SOUTH CAROLINA ELECTRIC & GAS COMPANY

Subject: Virgil C. Summer Nuclear Station  
Docket No. 50/395  
Operating License No. NPF-12  
Seismic Confirmatory Program

This letter serves to transmit formally ten copies of the responses to Staff questions discussed on April 28, 1983, and the further questions contained in the meeting summary. The initial questions are numbered 1-6 as in the Staff's letter. The questions labeled 1 and 2 in the NRC's meeting summary are herein labeled 3A and 2A respectively.

Figure 3A.4 Comparison of calculated Auxiliary Building response spectra obtained for the 84th and 16th percentile spectral modulus ratios for site F1 (upper two traces) and site P2 (lower two traces).

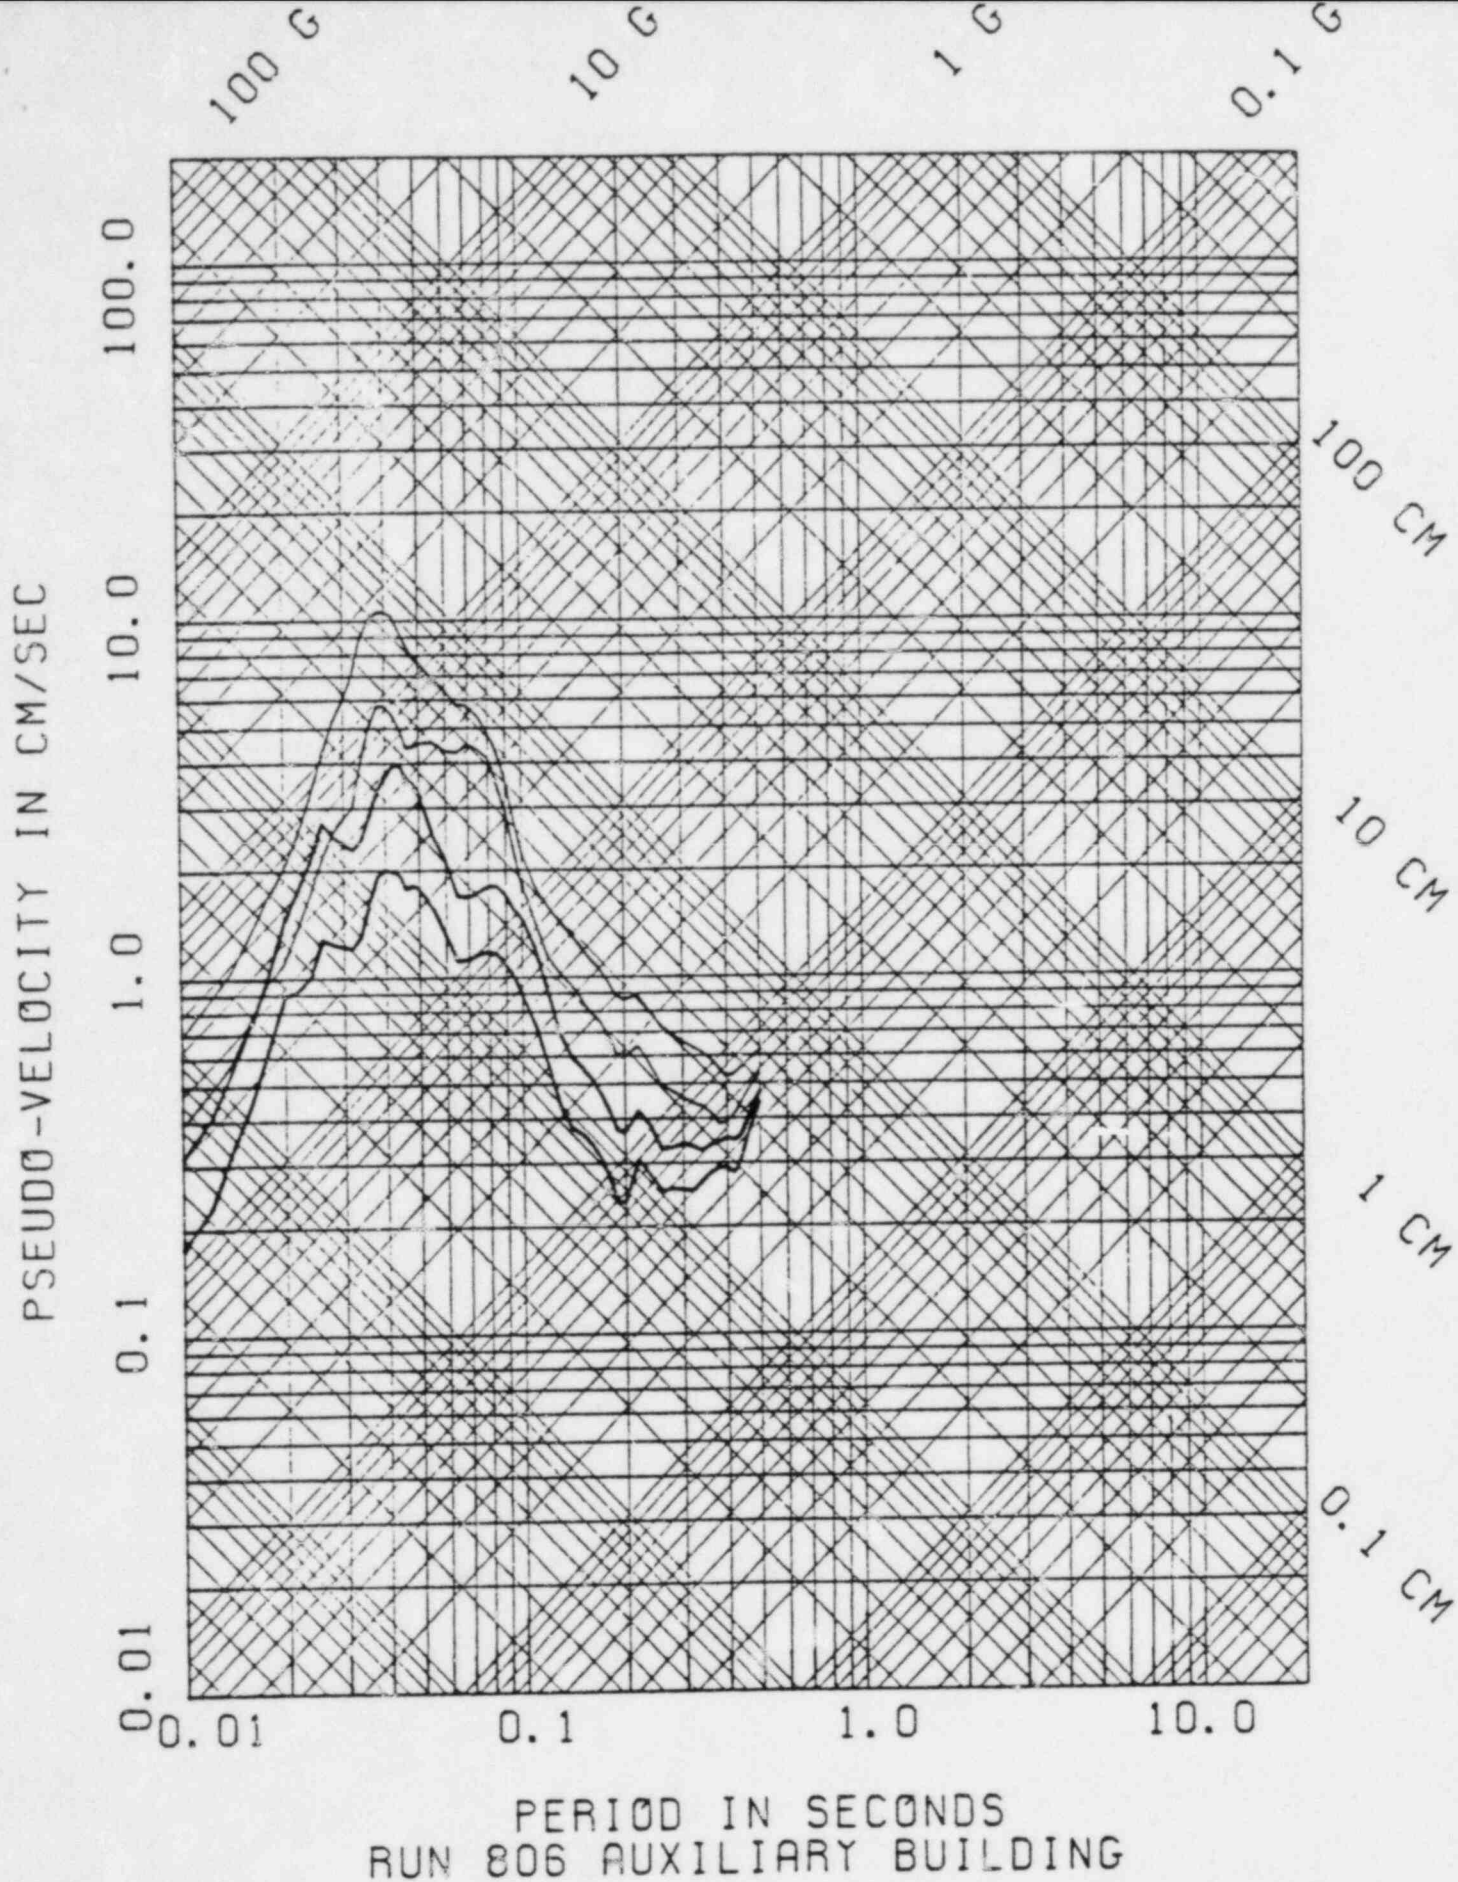
Question 3A.  
(New Q. 1)

To examine site differences in further detail, shot sequence statistics were calculated for Auxiliary Building/site spectral modulus ratios for sites F1 and P2 (the USGS accelerograph site). Figure 3A.4 compares Auxiliary Building foundation response spectra calculated for the 16th and 84th percentiles of the spectral modulus ratios for F1 and P2. The separation of the results for the two sites demonstrates the significance of the site effect. Although there may be a contribution due to path differences, this is a relatively small effect as can be seen by comparing Figures VI.C.47 and VI.C.48 of Appendix B, which show very similar Auxiliary Building/dam abutment spectral modulus ratios for Tests 4 and 1.
